Ducted Systems Technical Services Service Tips Letter

Letter: ST-005-2021

Subject: **Product Enhancement – Flare Pressure Transducer**

Product: YZV, YXV, AC21, HC20, AL21, HL20

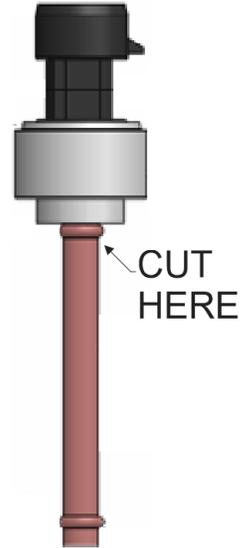
For units built with sweat style transducers that experience a failure, Source One kits were set up that contain a flare style transducer, a Schrader valve body, Schrader core, and installation instructions. See an example of a Source One transducer kit below.

To install a flare type transducer in place of a sweat type transducer, the sweat type transducer must be removed and replaced with a brass ¼ male flare connector like the one shown above. Since this is a brass to copper braze connection, a technician very proficient in brazing must make the repair.

Part numbers listed below are for flare style pressure transducer kits.

S1-32552072000 KIT, TRANSDUCER, DISCHARGE
S1-32547941000 KIT, TRANSDUCER, SUCTION
